ADDENDUM	Document Identifier	N/A	Rev	N/A
		Effective Date	N/A		
		Review Date	N/A

Suppliers Clarifications and Answers

MONITORING OF KOMATI POWER STATION ASH DAMS AND WATER DAMS FOR A PERIOD OF 03 YEARS

Tender number: E1863GXMPKOM

Figure 1: Komati Ash Dam Facility

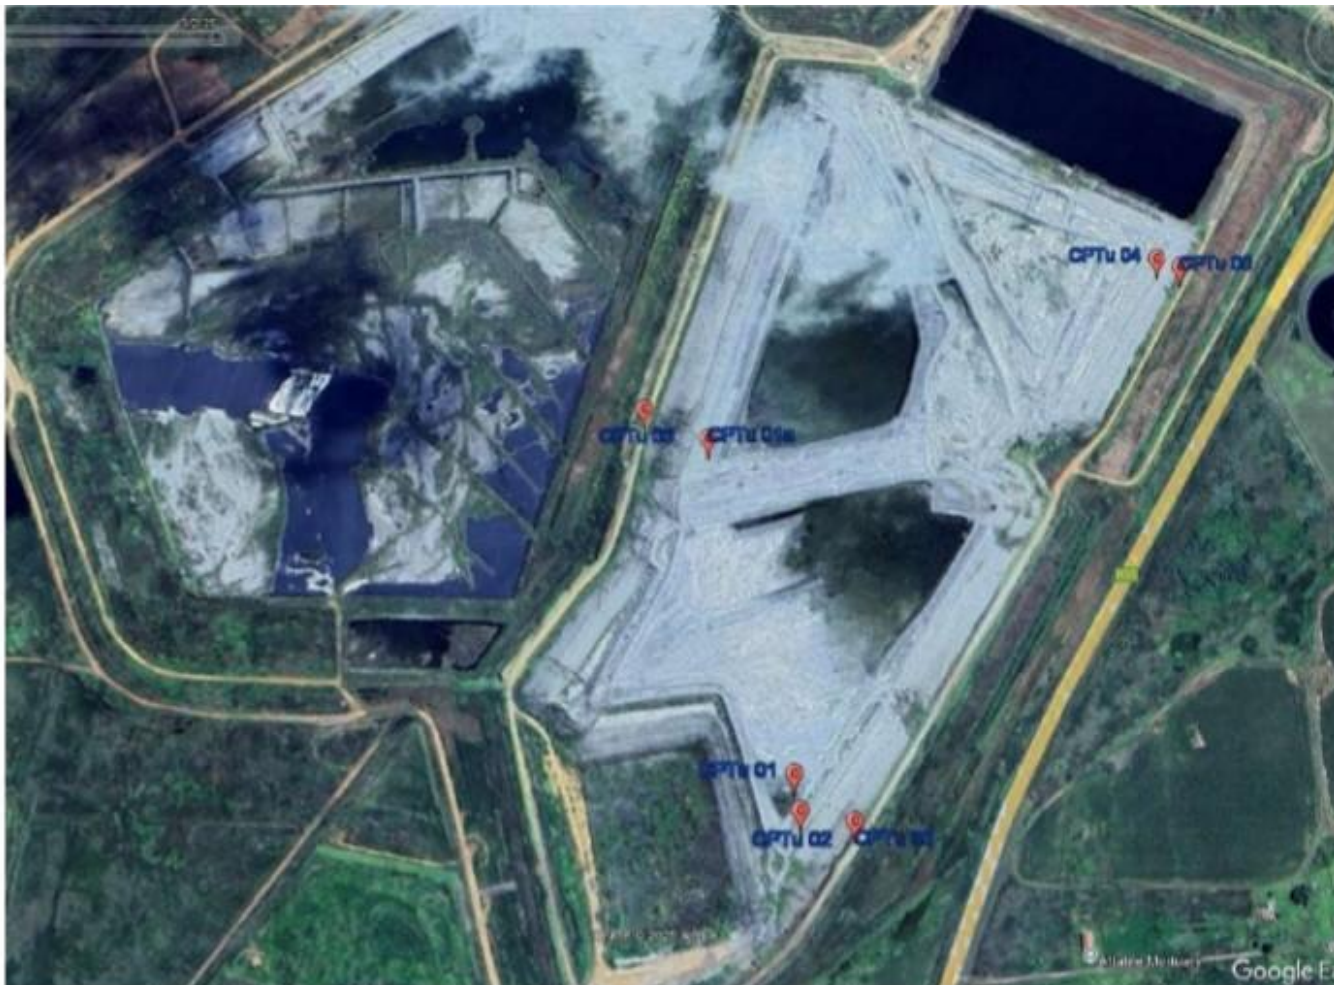
5.2. Are there any existing or previously conducted geotechnical investigations (e.g., drilling logs, test pits, SCPTu results) for the ash or water dams?

5.3. If available, please indicate the locations and scope of any previous investigations.

Current available CPTu tests are for only the Old Ash Dam Complex and they were done this year. The scope and the test positions are as shown in the image below.

The scope of work for the site investigation included the following:

- Cone Penetration Testing (SCPT) on 6 (six) locations
 - CPT test: 6 (six) No.
 - Probing: 30 m or refusal (180m total)
 - Dissipation: 5m intervals (1080 minutes)

There will be a requirement for CPTu tests to include AWR dam as it is also an earth embankment dam and is currently operational [AWR dam is the dam north of the Old Ash Dam complex in the image above]. In terms of the number of test positions for AWR, the appointed contractor will advise.
